# Leeds Bradford Airport Airspace Change Proposal

## Consultation Feedback Report

Reference	Description
<b>Document Title</b>	Leeds Bradford Airport Airspace Change Proposal
	Consultation Feedback Report
<b>Document Ref</b>	70818 049
<b>Issue</b>	Issue 1
<b>Date</b>	20 June 2018
<b>Client Name</b>	Leeds Bradford Airport
<b>Classification</b>	For Public Release

Figure 4 - Number of Objections Raised to Specific CTAs

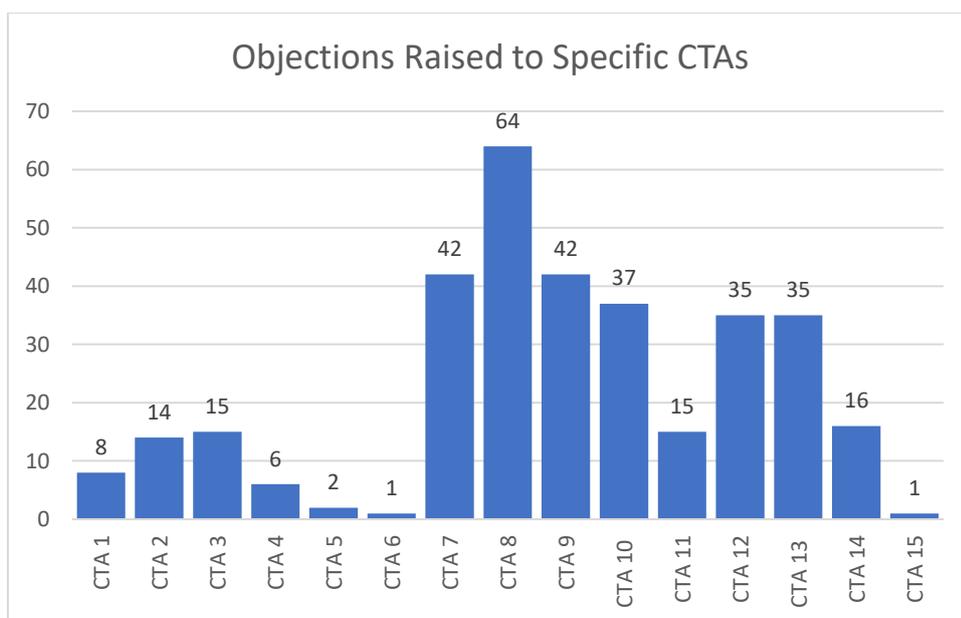
Additionally, the number of objections relating to each CTA were analysed to identify the areas of CAS that are deemed to be the cause the most concern for aviation and non-aviation stakeholders. The results of the analysis are shown in Figure 4 below.

Figure 5 - Consulted CAS Design Concept

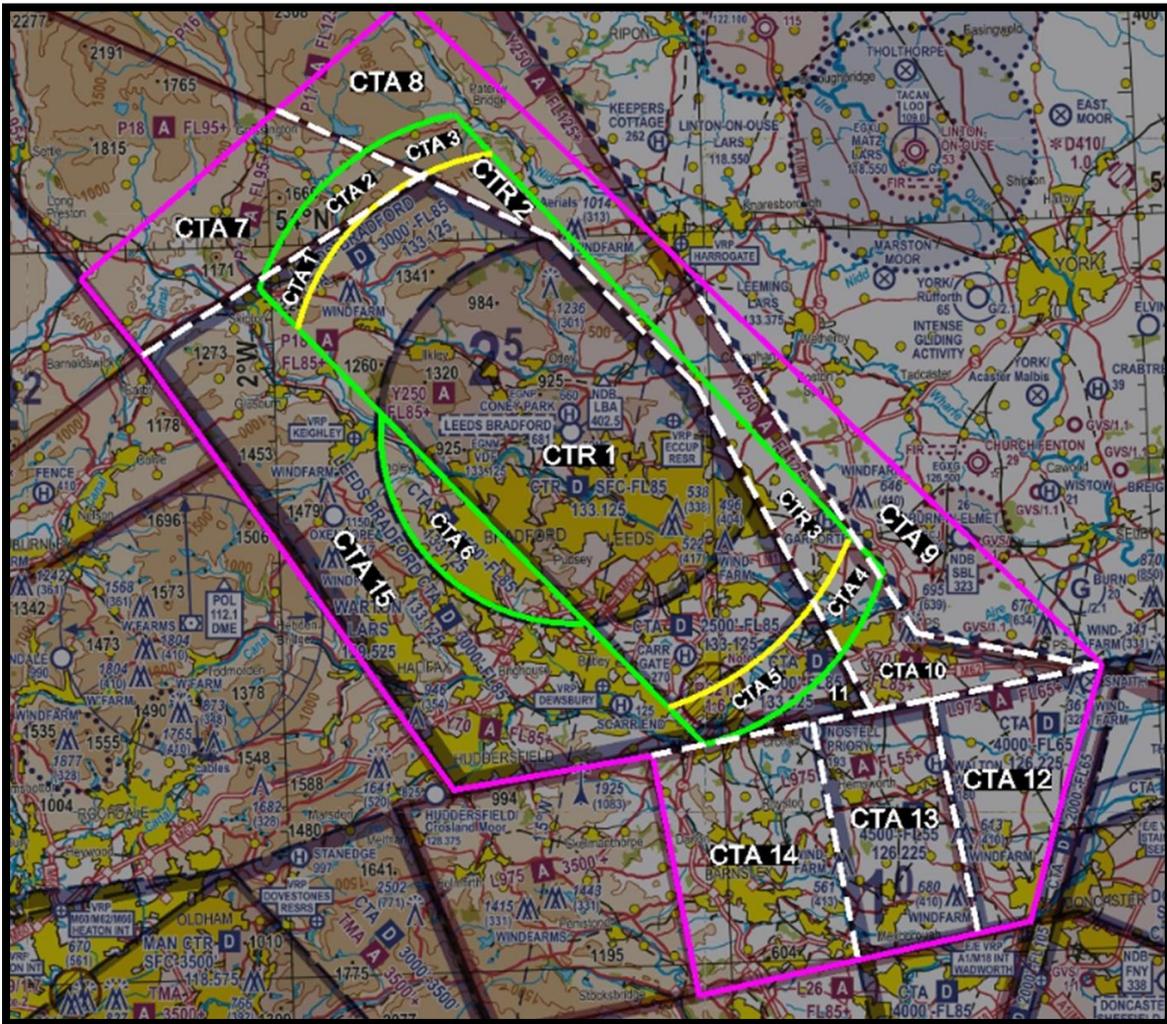
Area	Key Response Theme/Suggested Changes to Proposed Design	Implications of Consultees' Suggested Changes	Design Modifications for CAA Submission
All	<ul style="list-style-type: none"> <li>– Reduce number of areas and levels</li> <li>– Simplify the airspace</li> <li>– Reduce all airspace</li> <li>– Institute a common base of 4,500/5,000ft</li> </ul>	<p>CAA Policy requires a balance between the volumes of airspace requested against the complexity of the resulting airspace. LBA considers that the proposed volume of airspace is the minimum required to protect its operations along these new routes.</p> <p>The airspace design needs to fit within the existing airspace structures. This includes the national airways network and the existing CAS for DSA. LBA considers that the present balance is right between competing viewpoints. Although this makes for a complex design, LBA and DSA have agreed to work together in managing this overlapping airspace effectively in the future.</p>	<p>LBA is content for pilots of powered/non-powered aircraft to call in order to facilitate access to the airspace.</p> <p>Furthermore, LBA is introducing a new control position: Radar Director. This will ensure that controllers have the capacity to speak to pilots who wish to transit the airspace.</p> <p>LBA has already introduced a 'listening squawk' and will, in the future introduce Mode S which will further enhance this capability. LBA is planning a new RDP for controllers that will support Mode S. Mode S will allow controllers to interrogate aircraft callsigns and will help when used in conjunction with the listening squawk facility.</p> <p>Each section of airspace is considered separately.</p>

<ul style="list-style-type: none"> <li>– Reduce activation times</li> </ul>	<p>Because airspace in the UK cannot be activated and de-activated dynamically in an effective manner that provides the requisite safety assurance, we consulted on a 'hard time' activation/deactivation process for a number of the CTAs.</p> <p>The consultation stated this would allow use of these areas (or parts thereof) by the GA and other aviation stakeholders during the day between 0900 and 1800.</p> <p>The intention was to provide improved access to the GA community, but in doing so, this would constrain the arrival options for aircraft making an approach to RW 32. It would also add greater complexity to the sequencing of all arrivals to RW 32 at LBA. Aircraft would need to be vectored to the</p>	<p>Of the responses received that specifically mentioned time based activation of CTAs, there was a clear objection to this solution because it would add an unacceptable level of complexity.</p> <p>Furthermore, a much larger number of responses objected to the time based solution based upon the impact on the Upton Corridor.</p> <p>Considering the impact on the Upton corridor, complexity of this solution and the resultant environmental consequences, LBA now considers a better alternative to the time based activation/deactivation of airspace proposal</p>

Area	Key Response Theme/Suggested Changes to Proposed Design	Implications of Consultees' Suggested Changes	Design Modifications for CAA Submission
		south west of the airport increasing number of track miles flown (fuel burn) and reducing the likelihood of a Continuous Descent Approach (CDA) being flown; all of these options have negative environmental impacts.	would be publication in the UKIAIP of an agreed VFR corridor for use by the GA community, subject to agreed conditions; in effect this would be a modified and enhanced 'Upton Corridor'.  Additionally, LBA is investigating the possibility of raising the base levels of CTAs 12, 13 and 14 from 3,500 ft to 4,000 ft. In addition, LBA will seek to modify the lateral dimensions of CTA 10 to provide a consistent base level of 4,000 ft amsl within the area.
	– Utilise Class E instead of Class D	The suggested option to designate some airspace as Class E instead of Class D, was considered by LBA not to provide adequate levels of safety to the large volume of passenger flights that operate in and out of LBA. Furthermore, different rules associated with Class E airspace create additional complexity that would significantly affect the wide variety of GA traffic operating within the vicinity of LBA, as well as increasing the likelihood of infringement.	On safety grounds, LBA therefore considers that the use of Class E airspace is not suitable in this instance, given the limited volume of airspace available in the UK compared to other areas within Europe.

Area	Key Response Theme/Suggested Changes to Proposed Design	Implications of Consultees' Suggested Changes	Design Modifications for CAA Submission
CTR 1	<ul style="list-style-type: none"> <li>Remove airspace above Addingham Moorside</li> </ul>	<p>LBA was not aware of this launch site. There is no indication on the VFR map of a launch site in this location. The DHPC website indicates that this is para-gliding launch site with no permanent fixed facilities associated with it. LBA considers that an alternative launch site may need to be used.</p> <p>CTR 1 is designed to contain the proposed procedures, changing the dimensions of CTR 1 may result in the procedures not being contained. Equally, moving CTR 1 would lead to a ripple effect on other areas of proposed CAS. If the size of CTR 1 was reduced, CTAs 1, 2 and 3 would need have their bases lowered.</p>	<p>LBA remains receptive to any request to access any part of its CAS by prior arrangement and this is the case for areas of airspace used by the paragliding community.</p> <p>LBA would be pleased to engage with the paragliding community at Addingham Moorside to develop a LoA that would allow operations to continue safely within the area.</p>

Area	Key Response Theme/Suggested Changes to Proposed Design	Implications of Consultees' Suggested Changes	Design Modifications for CAA Submission
	<ul style="list-style-type: none"> <li>- Do not implement</li> <li>- Combine CTAs 1, 2 and 3 into one area</li> </ul>	<p>There is no mechanism for the dynamic management of airspace within the UK.</p> <p>CTAs 1, 2 and 3 cannot be merged into a single CTA since each area has a separate vertical top limit which is consistent with the existing airspace structure. If the ACP is successful, LBA will attempt to simplify how this is portrayed on the VFR chart to make it easier to interpret. However, the overall decision on how the information is to be presented lies with NATS, who publish the charts for and on behalf of the CAA.</p>	<p>LBA is undertaking a complete review of their existing VFR brief to highlight areas where pilots can expect to be routed when issued with a clearance.</p>

Area	Key Response Theme/Suggested Changes to Proposed Design	Implications of Consultees' Suggested Changes	Design Modifications for CAA Submission
CTA 5	<ul style="list-style-type: none"> <li>- Raise base to 5,000ft</li> </ul>	<p>The proposed base is required to ensure departing aircraft from RW 14 and arrivals for RW 32 are protected.</p>	<p>CTA 5 is currently in an area where the base is already 3,000 ft amsl and LBA does not propose to alter this for the ACP submission.</p>
CTA 6	<ul style="list-style-type: none"> <li>- Do not implement</li> </ul>	<p>CTA 6 is required to ensure proposed procedures are safely contained. This has been designed in accordance with ICAO PANS OPS containment criteria.</p>	<p>The base level of the existing CAS in this area is 2,500 ft amsl. LBA will investigate the possibility of raising this base level provided that it does not conflict with CAA containment policy.</p>

Area	Key Response Theme/Suggested Changes to Proposed Design	Implications of Consultees' Suggested Changes	Design Modifications for CAA Submission
		<p>piece of airspace is introduced between CTA 7 and CTA 8. This would overcomplicate the airspace design.</p> <p>Additionally given the changeable weather conditions, it is not possible to assume dominance of operations to either runway end. The mixed nature of departures and arrivals to opposite end runways means that to make use of the longer west arrival an additional piece of airspace between CTA 7 and CTA 8 would be required and this further complicates an already complex airspace design.</p>	
<b>CTA 9</b>	<ul style="list-style-type: none"> <li>- Raise base to FL55 (between 0900 and 1800)</li> <li>- Remove CTA 9</li> <li>- Extension of airspace to North and East should be not below 8000ft between 0900 and 1800</li> </ul>	<p>CTA 9 is designed to protect arrivals for RW 32 as it allows arrivals to be sequenced and separated from the departures that largely route to the west of LBA.</p> <p>Because airspace in the UK cannot be activated and de-activated dynamically in an effective manner that provides the requisite safety assurance, we consulted on a 'hard time' activation/deactivation process for a number of the CTAs.</p> <p>The consultation stated that this would allow use of these areas (or parts thereof) by the GA and other aviation stakeholders during the day between 0900 and 1800.</p> <p>The intention was to provide improved access to the GA community, but in doing so, this would constrain the arrival options for aircraft making an approach to RW 32 during some of the busiest periods of the day. Aircraft would instead need to be vectored to the south west of the airport, which potentially would conflict with the departures, increasing number of track miles flown (fuel burn) and reducing the likelihood of a Continuous Descent Approach (CDA) being flown; all of these options have negative environmental impacts.</p>	<p>LBA would prefer to offer an alternative solution to providing access to this airspace to GA and other aviation stakeholders.</p> <p>This would involve a tactical clearance being requested, or by utilising a modified and enhanced version of the Upton Corridor that would be published in the UKIAIP.</p> <p>Additionally, LBA is investigating the possibility of raising the base levels of CTA 9 from 3,500 ft to 4,000 ft. In addition, LBA will seek to modify the lateral dimensions of CTA 10 to provide a consistent base level of 4,000 ft amsl within the area.</p>

<b>CTA 10</b>	<ul style="list-style-type: none"> <li>- CTA 10 should be raised to at least 4,500ft/5000ft/FL55 until 2000 during the summer</li> </ul>	<p>This CTA is designed to protect the arrivals for RW 32 which is the dominant RW used at LBA.</p> <p>To facilitate this change, LBA would be limited to the short west arrival for Runway 32 which potentially would conflict</p>	<p>LBA is investigating the possibility of raising the base levels of CTAs 12, 13 and 14 from 3,500 ft to 4,000 ft. In addition, LBA will seek to modify the lateral dimensions of CTA 10 to provide a</p>

Area	Key Response Theme/Suggested Changes to Proposed Design	Implications of Consultees' Suggested Changes	Design Modifications for CAA Submission
	<ul style="list-style-type: none"> <li>Wedge jutting out to the ease of CTA 10 could be merged with CTA 9 and the remainder with the tiny CTA 11</li> </ul>	<p>with the departures and would in turn prevent a CDA being flown with consequential negative environmental impacts.</p> <p>CTA 9, 10 and 11 have different top levels so they cannot be merged into one CTA in their current form.</p>	<p>consistent base level of 4,000 ft amsl within the area.</p>
<b>CTA 11</b>	<ul style="list-style-type: none"> <li>If CTA 11 at 3000ft is really essential, then some effort must be made to shorten or eliminate the triangular 'foot' of CTA10 perhaps by carrying the eastern boundary directly down to meet the northern point of the boundary between CTAs 12 and 13</li> <li>Raise lower altitude from 3,000ft to FL55 of the SE corner of CTA 11</li> <li>Raise base to 5,000ft</li> </ul>	<p>The proposed base level of CTA 11 is 3,500 ft amsl which is 500 ft higher than the existing airspace within this area.</p> <p>This CTA is required to contain and protect the arrivals for RW 32.</p> <p>CTA 9, 10 and 11 have different top levels so they cannot be merged into one CTA in their current form.</p>	<p>LBA has raised the base level of the airspace within this area by 500 ft and does not propose to alter this for the ACP submission.</p>

Area	Key Response Theme/Suggested Changes to Proposed Design	Implications of Consultees' Suggested Changes	Design Modifications for CAA Submission
CTA 15	<ul style="list-style-type: none"> <li>- Raise base to 5,000 ft</li> </ul>	<p>The existing LBA CAS within this area has a base level of 3,000ft. Therefore no change has been proposed.</p> <p>This area is designed to protect the current SIDS and will be required to protect the new IFPs.</p>	<p>CTA 15 is currently in an area where the base is already 3,000 ft amsl and LBA does not propose to alter this for the ACP submission.</p>
